# **Suncor Energy Inc.**

## **Applications for Millennium Operational Amendment and Base Plant Tailings Management Plan**

Decision 20171025A: Suncor Energy Inc., Applications for Millennium Operational  
Amendment and Base Plant Tailings Management Plan

**Figure 1. Profile of legacy (equivalent) fluid tailings**

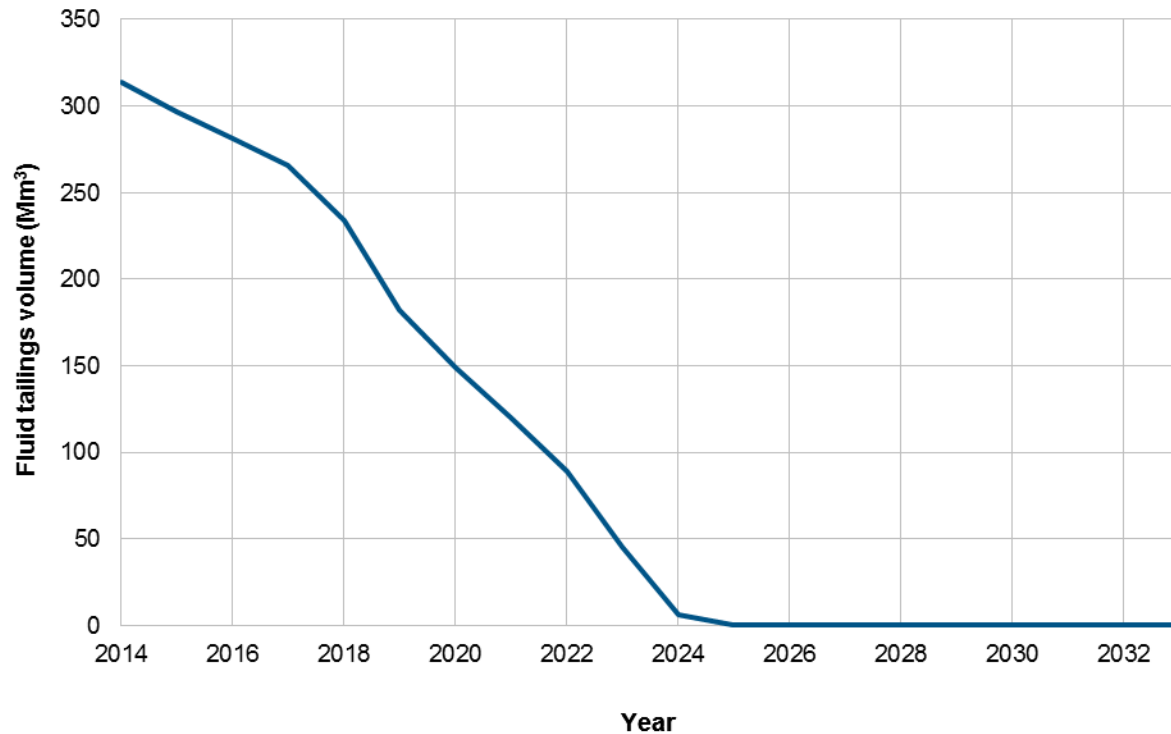
[53] No specific concerns regarding Suncor's profile of legacy (equivalent) fluid tailings were raised by SOC filers. However, they did highlight the importance of progressive reclamation and managing legacy tailings ponds. OSEC expected that any future changes to RTR criteria do not result in a change to Suncor's profile.

[54] The AER agrees that effective management of reclamation progress requires timely reporting and robust monitoring and planning. Suncor's legacy (equivalent) fluid tailings profile meets the objective of the TMF because an equivalent volume of Suncor's legacy fluid tailings will be progressively treated during mine life and will achieve RTR status by 2025, eight years before the end of mine life.

**Figure 2. Profile of new fluid tailings**

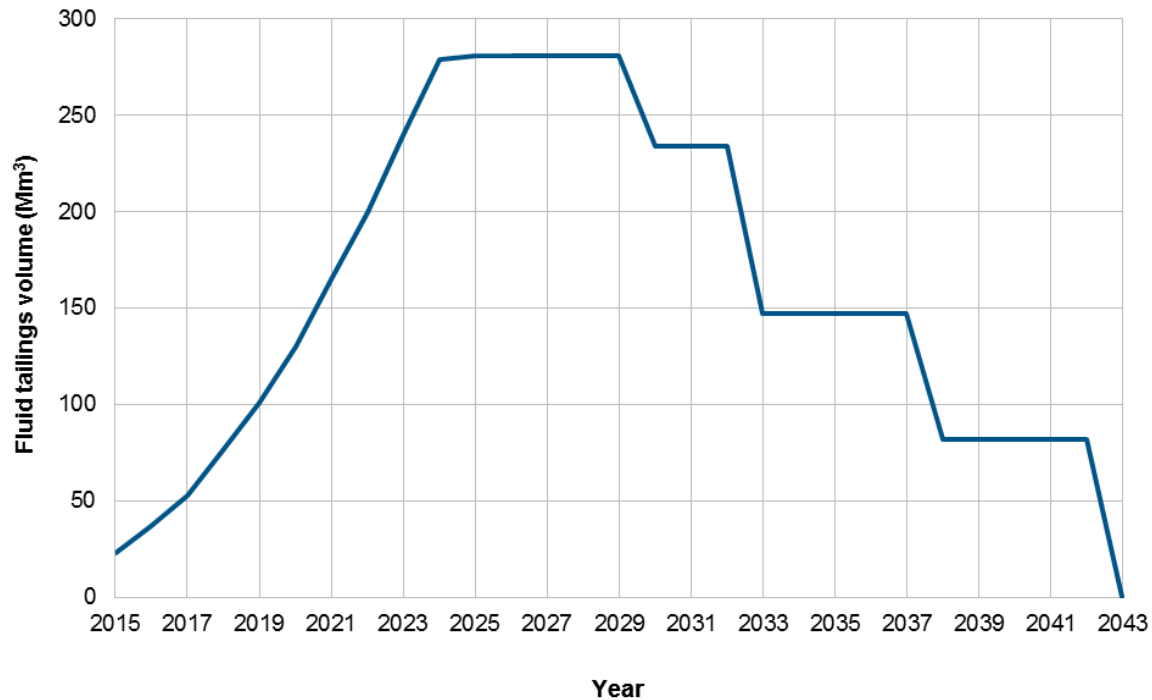
[63] No specific concerns regarding Suncor's profile of legacy (equivalent) fluid tailings were raised by SOC filers. OSEC expected that any future changes to RTR criteria do not result in a change to Suncor's profile.

[58] The AER finds that Suncor's new fluid tailings profile, with modifications, meets the objective of the *TMF*. The AER modified Suncor's new fluid tailings profile to require Suncor to achieve zero new fluid tailings volume (from 18 million cubic metres in Suncor's application) by 2043 (which is 10 years after mine life) to ensure compliance with the *TMF*.

[65] Based on this, the AER modified Suncor's new tailings profile to require Suncor to achieve zero new fluid tailings volume by 2043.
